SUBJECT: Application for amend to license DPR-23,consisting of new section to provide necessary criteria to perform 24 h full-load testing of EDGs.

RNP File No: 13510HA
Serial: RNP-RA/96-0005

H. B. ROBINSON STEAM ELECTRIC PLANT, UNIT NO. 2
DOCKET NO. 50-261/LICENSE NO. DPR-23
REQUEST FOR TECHNICAL SPECIFICATIONS CHANGE
EMERGENCY POWER SYSTEM PERIODIC TESTS

FIGURE 1

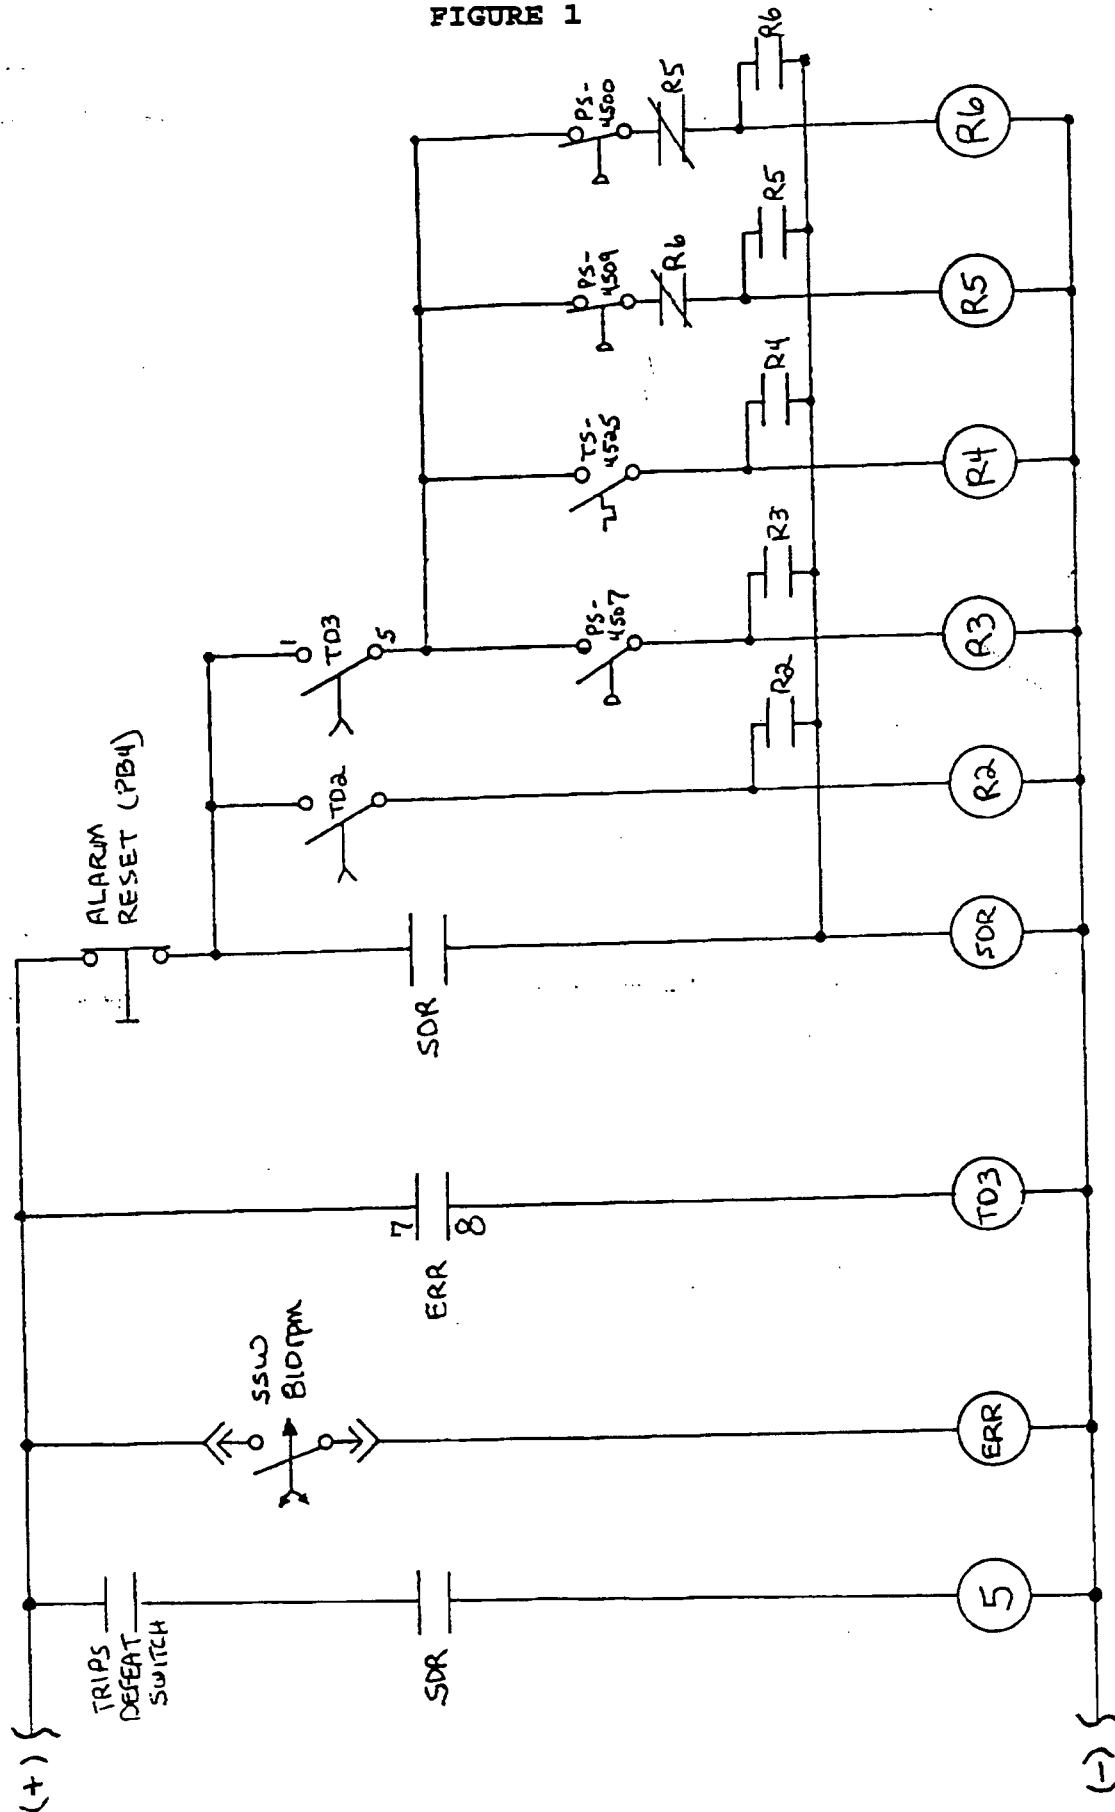
Testing the EDG protective bypasses, shown schematically in the enclosed Figure 1 "Emergency Diesel Generator Protective Bypasses," is also performed during the SI/LOOP test and consists of installing jumpers on the following devices to simulate actuation:

- a) Low Lube Oil Pressure Switch (PS-4500),
- b) Low Coolant Pressure Switch (PS-4509),
- c) High Coolant Temperature Switch (TS-4525),
- d) High Crankcase Pressure Switch (PS-4507), and
- e) Engine Start Failure Relay (TD2).

With the TRIPS DEFEAT switch in the "Trips Defeated" mode, the EDG should not trip when each of the devices listed above are bypassed. However, the EDG control logic and the TRIPS DEFEAT switch is designed such that the protective bypasses do not have to be tested during a refueling outage. The control logic does not have a permissive or interlock requiring the EDG to be in automatic to test these switches. The TRIPS DEFEAT switch is a manual key-lock switch that can be operated at any time. The only requirement to test the devices listed above is to ensure the TRIPS DEFEAT switch is in the "Trips Defeated" mode and DC control power is available. When a jumper is placed across a set of contacts simulating a device actuation, the Shutdown Relay (SDR) should energize but the "Stopping Relay" or "5 Relay" should remain de-energized. A similar test is presently being performed as part of post maintenance testing following calibration of these temperature and pressure switches at an 18 month interval. The only difference between this test and testing during the SI/LOOP test is, since the EDGs are not running, an additional jumper is required across relay TD3 contacts 1/5 which simulates EDG operation.

The proposed change to TS Section 4.6.1.2 will have a significant positive impact with respect to challenging a safety system. The present testing method of the EDG protective bypasses is accomplished while the emergency buses are separated from off-site power and the EDGs are supplying power. If the TRIPS DEFEAT logic failed and the EDG tripped, the associated emergency bus would lose power. The resultant transient could damage or degrade some of the safety related loads being fed from the emergency bus. The proposed revision to the TS Section will allow the protective bypass logic to be statically tested (i.e. with the EDG under clearance). This will prevent electrical transients from occurring if the TRIPS DEFEAT switch were to fail.

The proposed change to TS Section 4.6.1.2 to move the requirement for testing the diesel protective bypasses to TS Section 4.6.1.3 will not affect the ability of the EDGs to mitigate an accident. The requirement to perform this testing at a refueling interval during an EDG outage instead of during the SI/LOOP testing will not affect the ability of the EDGs to perform
